ADDENDUM NO. 2

**For
CHICAGO O'HARE INTERNATIONAL AIRPORT
BUILDING 521 RENOVATION FOR AIRPORT POLICE
SPECIFICATIONS AND CONTRACT DOCUMENTS NO. 335805**

CDA Project Number H4018.15-00

A 04 002

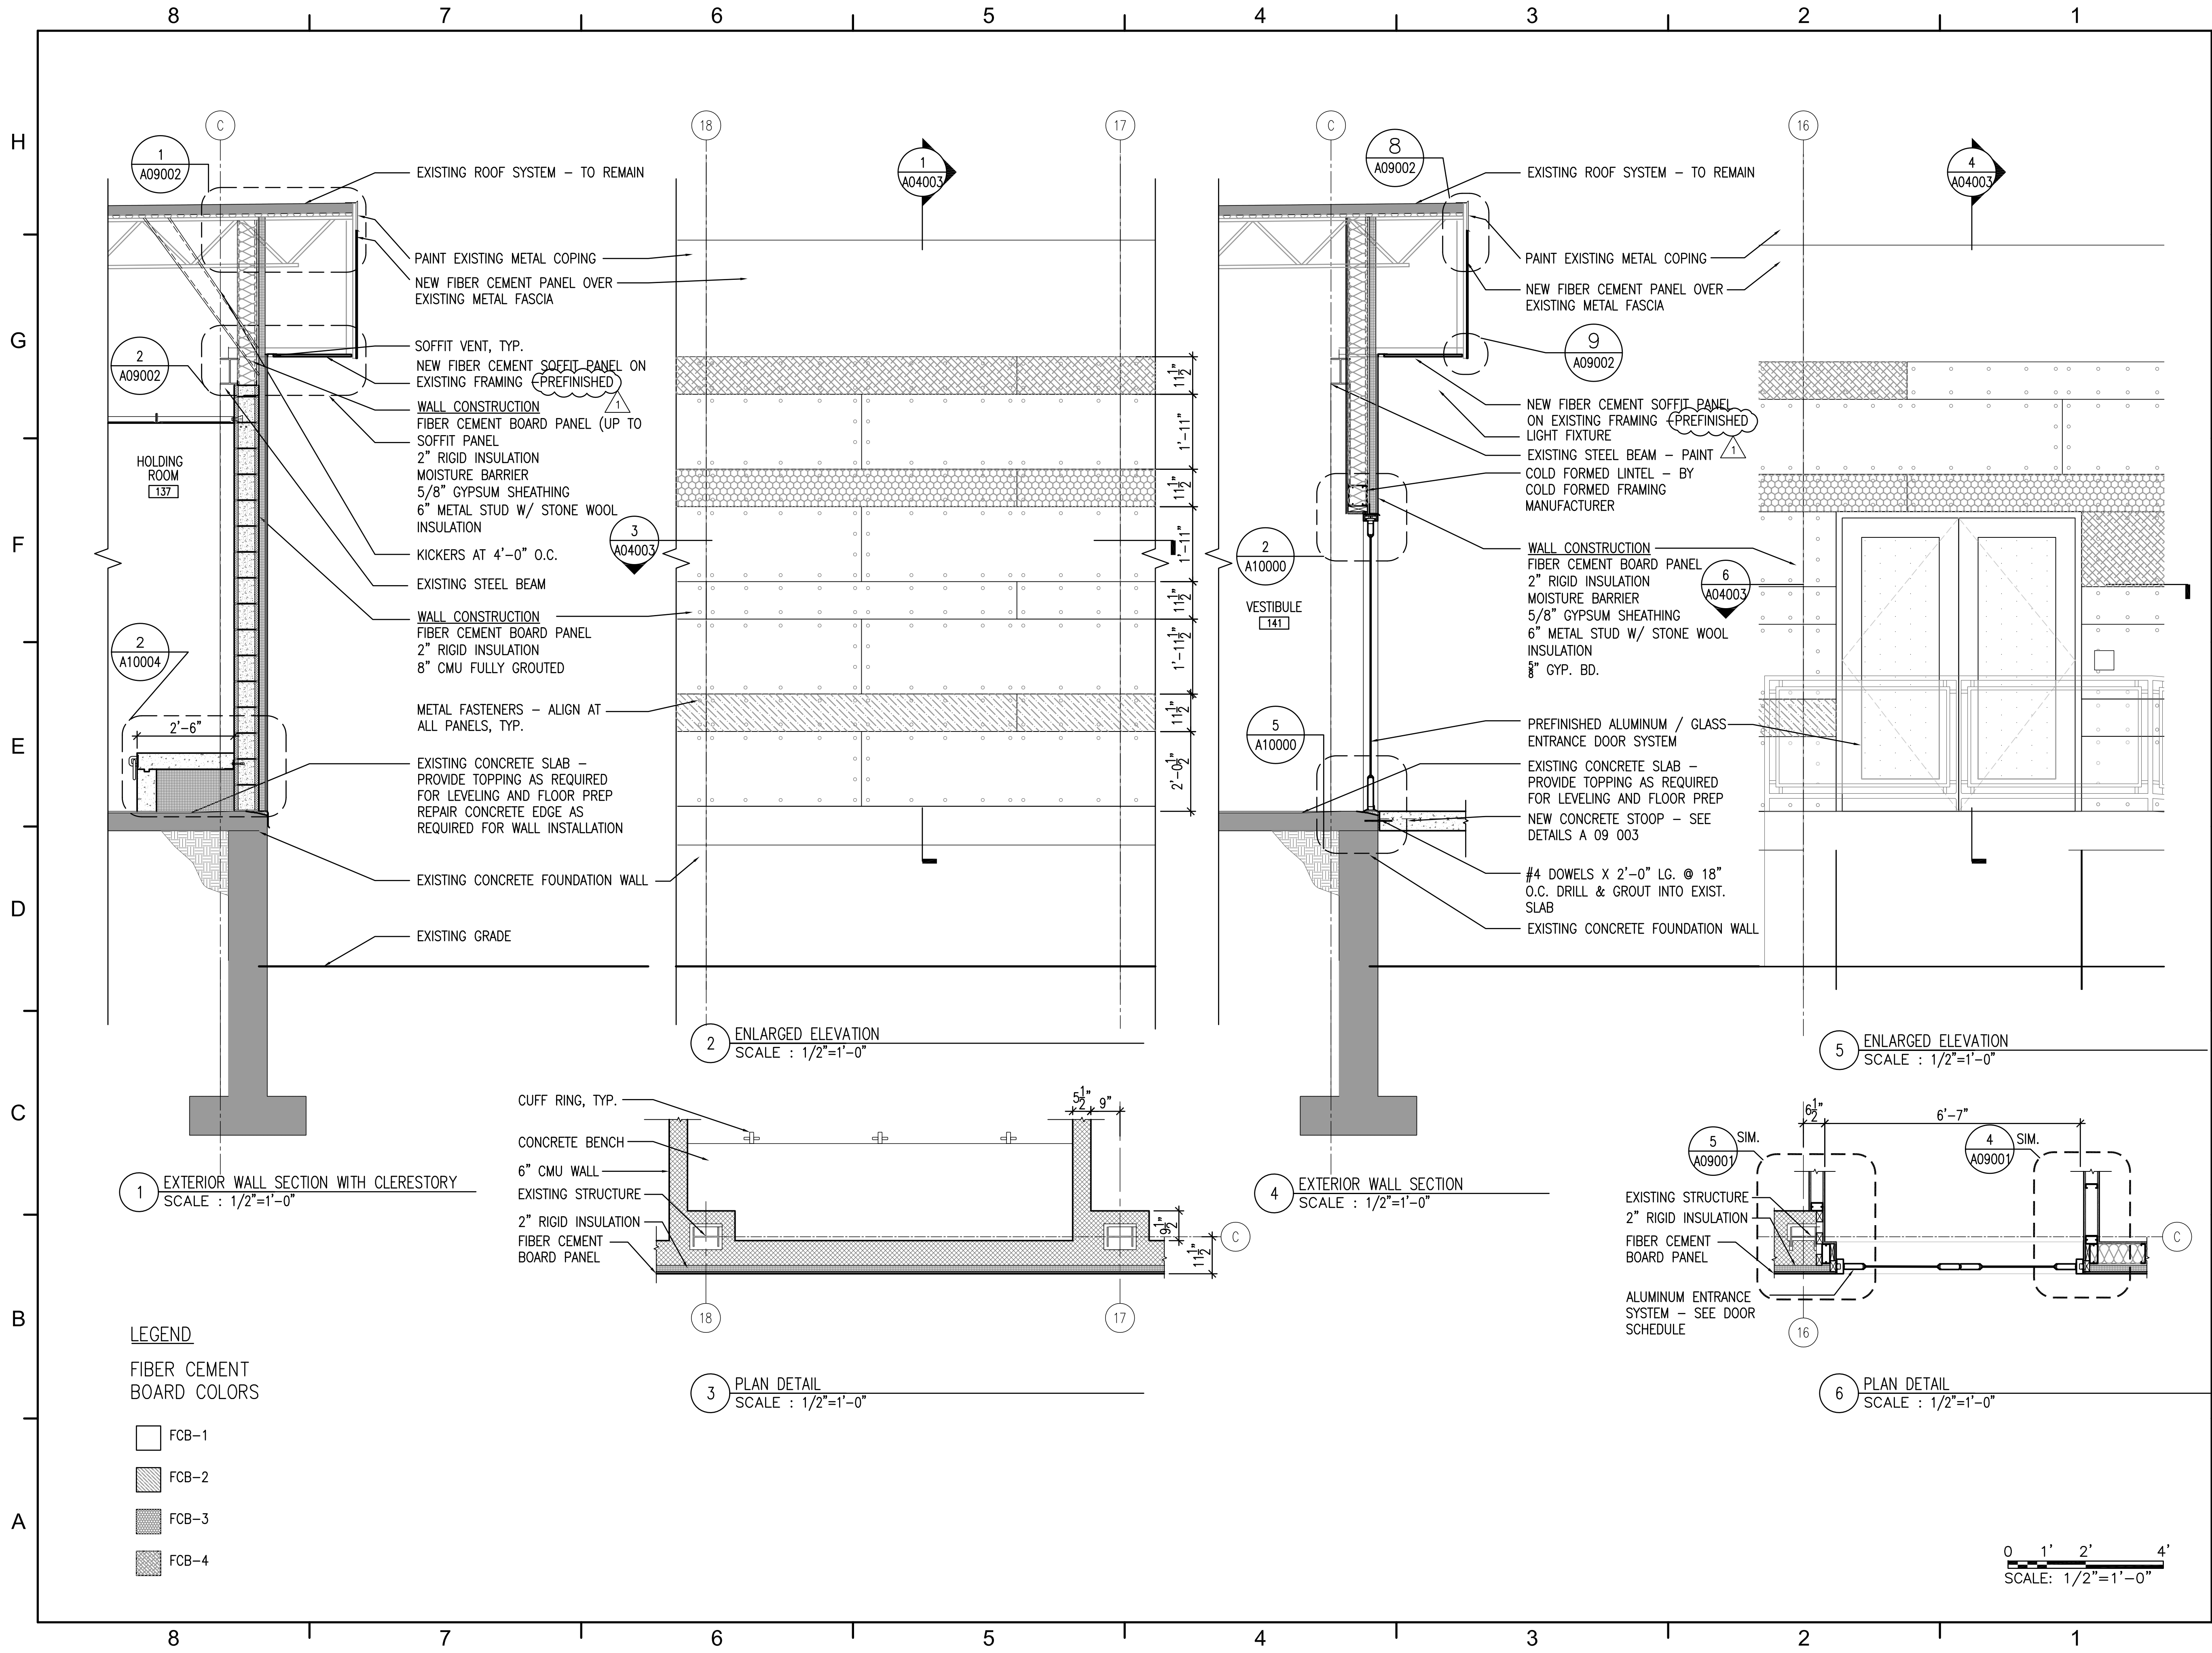
DRAWING	
1.A04-002 Details 1 & 5	Revised soffit material to read New Fiber Cement Soffit Panel On Existing Framing – Prefinished. (Attached)

Question 4:	Are the aluminum storefront windows AND doors receiving new paint (A 04 001 detail number 3) or will they be prefinished (A 04 002 detail #1)?

Response:	Aluminum windows and doors will be prefinished, see Spec Section 08411, Part 2.04, E.
Question 5:	Is the exterior Fiber Cement Soffit Panel getting painted (A 04 002 details # 1&3), or will all the Fiber Cement Board Colors be prefinished.

Response:	Fiber Cement Soffit Panels to be prefinished, see Spec Section 09900, part 3.07, D.
Question 6:	Will any of the walls in the Garage be painted? That room is not on the finish schedule

A 04 003

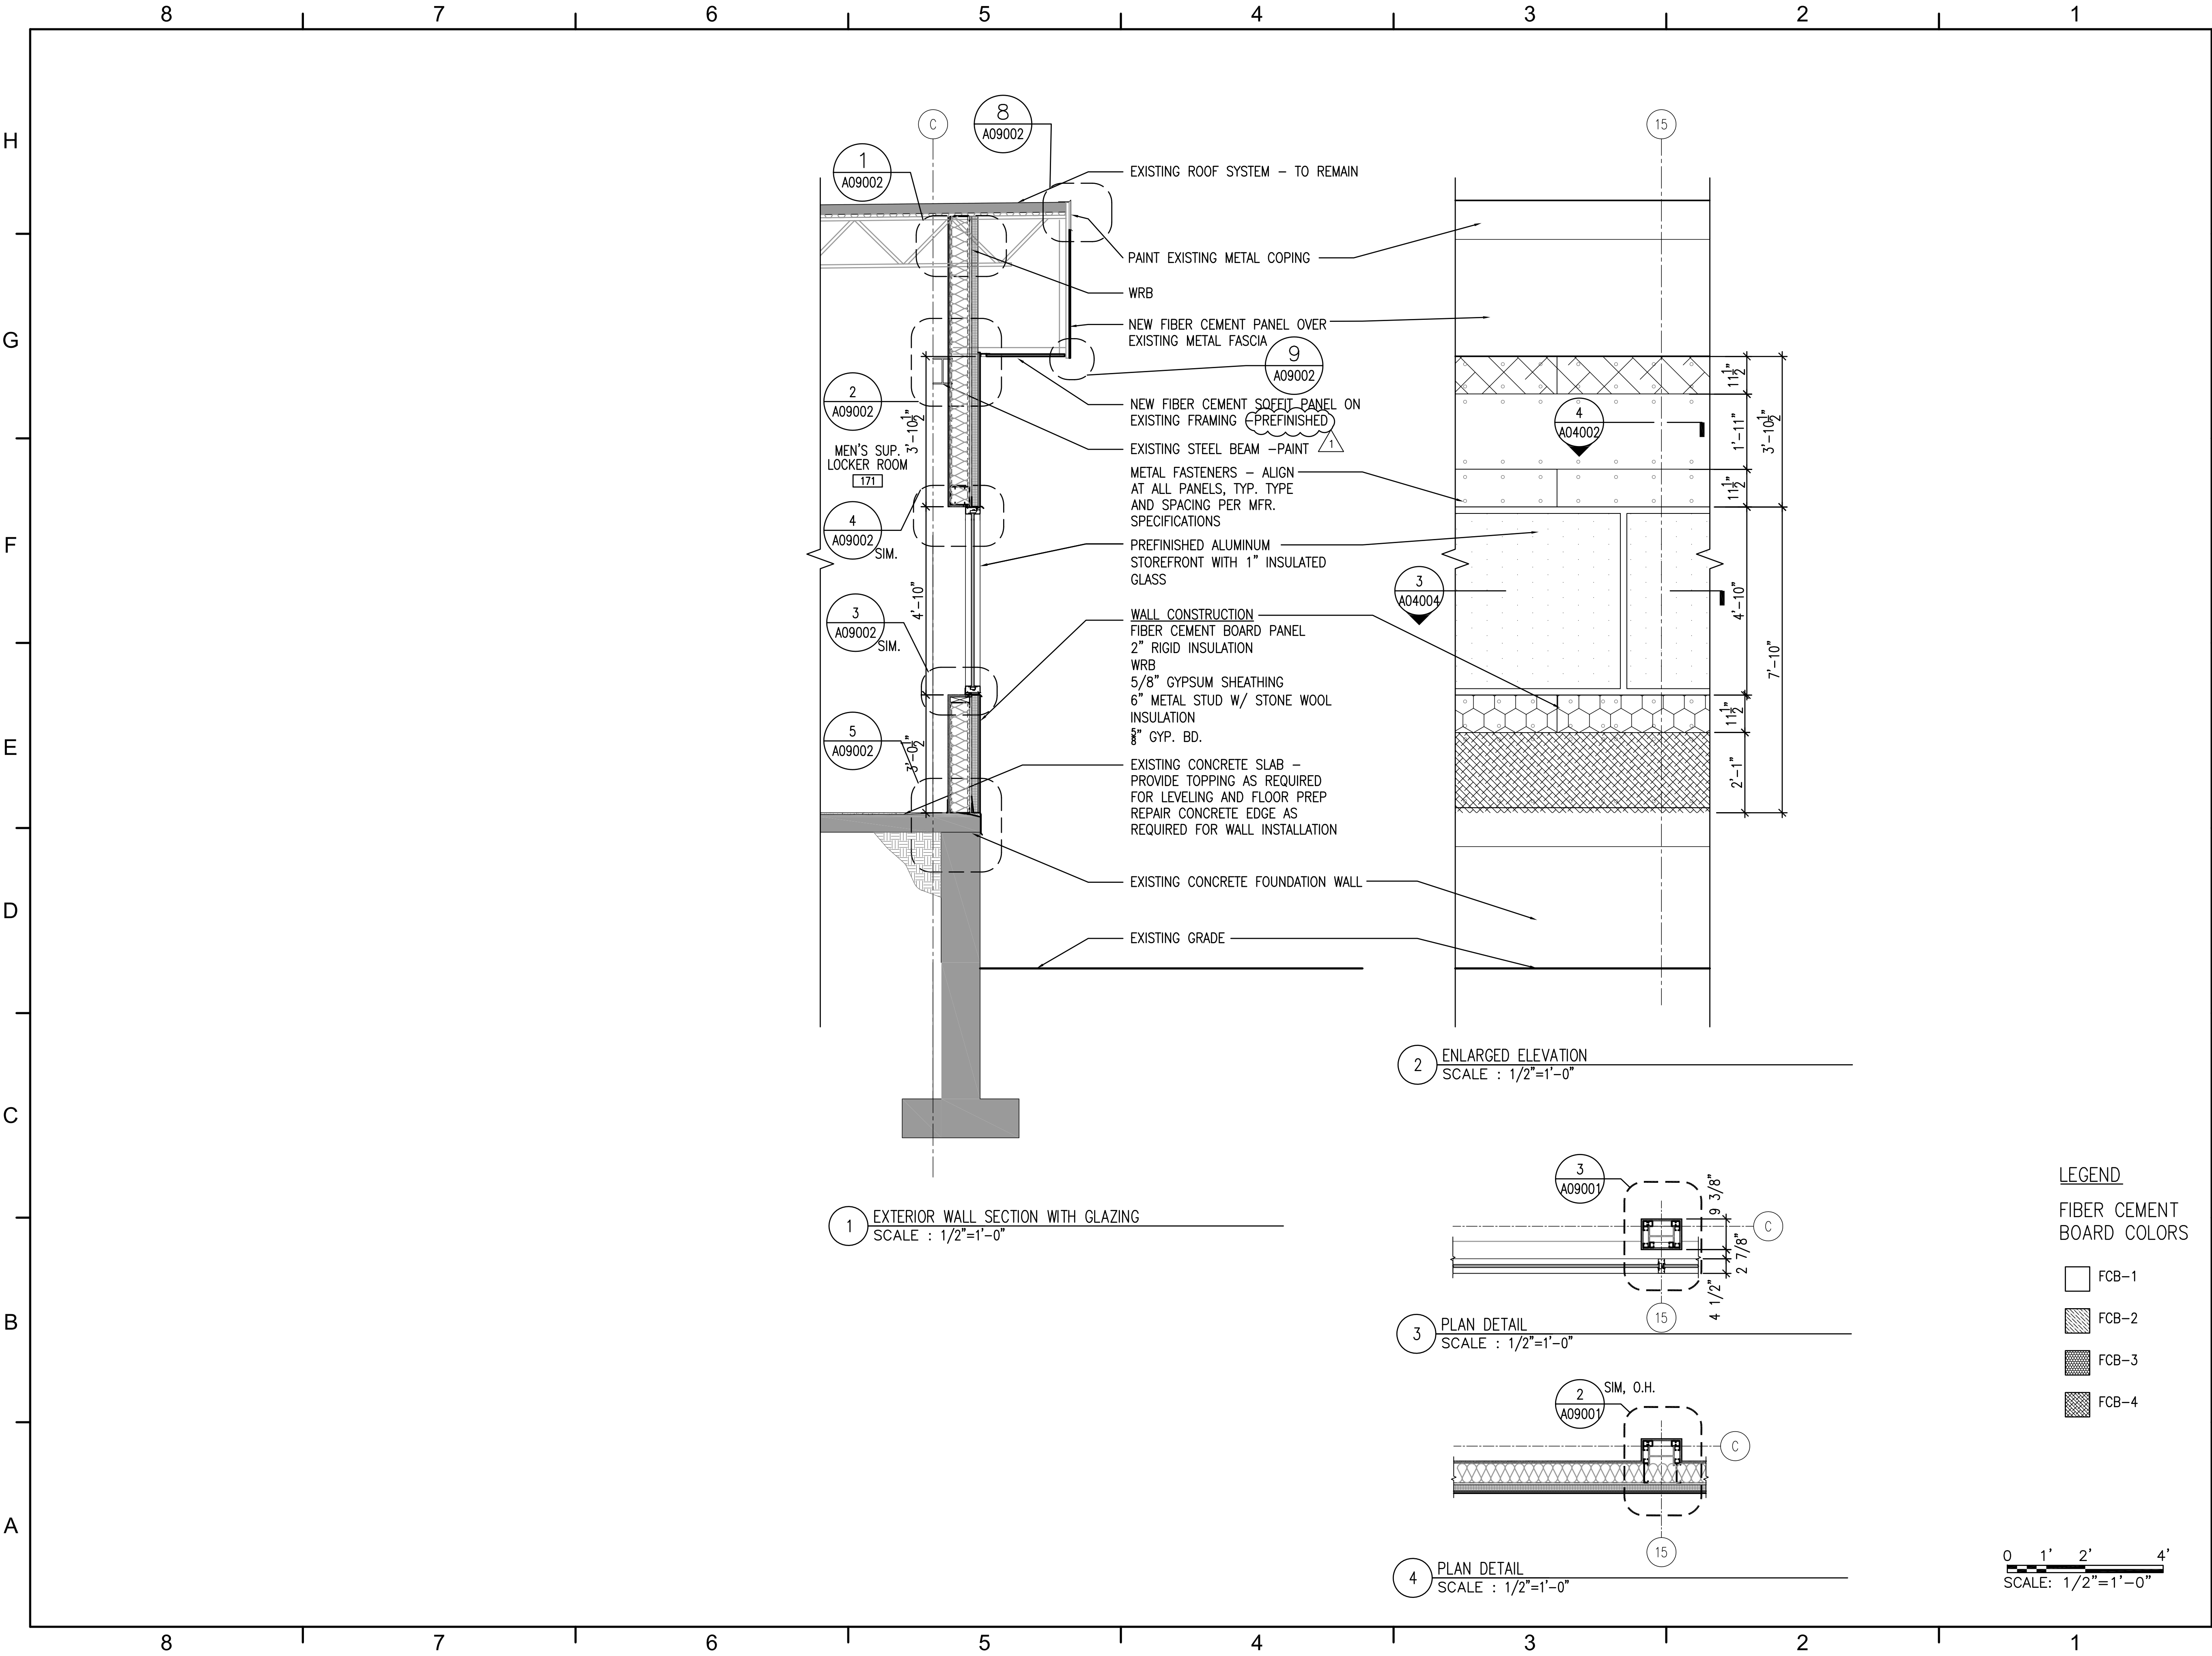
2.A04-003 Details 1 &4	Revised soffit material to read New Fiber Cement Soffit Panel On Existing Framing – Prefinished. (Attached)
3.A04-004 Detail 1	Revised soffit material to read New Fiber Cement Soffit Panel On Existing Framing – Prefinished. (Attached)
4.A009-002 Detail 2	Revised soffit material to read ¼” Fiber Cement Board Soffit Panel – Prefinished. (Attached)
5. A03-003 Door Schedule	Revised to include information on openings 168 and 200A. (Attached)
6. A03-002 Finish Schedule	Revised to clarify floor finishes at rooms 103, 104, 117, 118. (Attached)
